U.S. CONSUMER PRODUCT SAFETY COMMISSION
4330 EAST WEST HIGHWAY
BETHESDA, MD 20814

The pages that follow present the CPSC staff response¹ to the points outlined in the October 3, 2008 letter from the International Play Equipment Manufacturers Association (IPEMA) to Mr. Hugh McLaurin. Mr. McLaurin has since retired, but staff from the Directorate for Engineering Sciences, including myself, Ms. Celestine Kiss, and Mr. Mark Kumagai, assisted in preparing these responses. Additionally, we have included a list of other modifications we are making to the May 2008 draft of publication #325, *Handbook for Public Playground Safety*. This response includes revisions made as a result of the meeting in St. Louis May 18, 2010.

Point-by-Point response

List of all planned modifications to Public Playground Safety Handbook

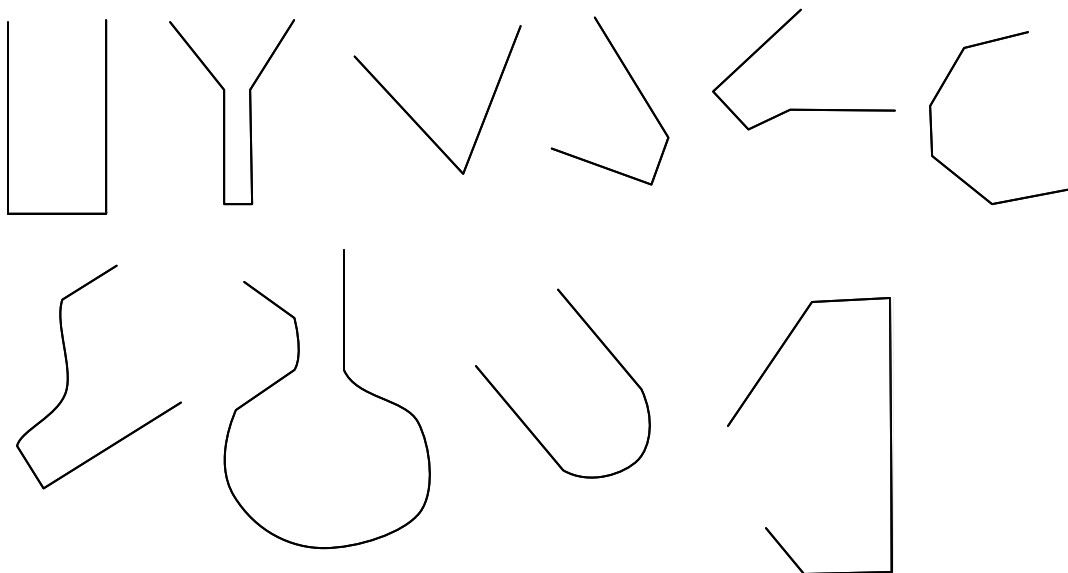
65. B.2.4 Angles: Delete section in its entirety, as it has been replaced by new section on Partially Bound Openings.
66. B.2.6.5 Flexible openings, Step 5: Modified to read “Determine *if* the probe can be pushed or pulled *completely* through the opening by a force no greater than 30 pounds on toddler playgrounds or 50 pounds on preschool-age and school-age playgrounds.”
67. B.2.6.5 Flexible openings, Step 5: Add representative Pass and Continue pictures provided.
68. B.2.6.5 Flexible openings, Step 7: Modified to read “Determine if the large head probe can be pushed or pulled *completely* through the opening by a force no greater than 30 pounds on toddler playgrounds or 50 pounds on preschool-age and school-age playgrounds.”
69. B.2.6.5 Flexible openings, Step 7: Add representative Pass and Fail pictures provided.
70. Appendix B: Add new section B.2.6.6 Partially Bound Openings.

A partially bound opening is any opening which has at least one side or portion open, such as a U- or V-shaped opening. These openings can still pose an entrapment hazard by allowing the neck to enter but not allowing the head to slip out. Several examples of this situation are shown in the figure below.

Note: Test procedure write-up is still in development and usability testing. Above graphics to be improved by graphic artist.
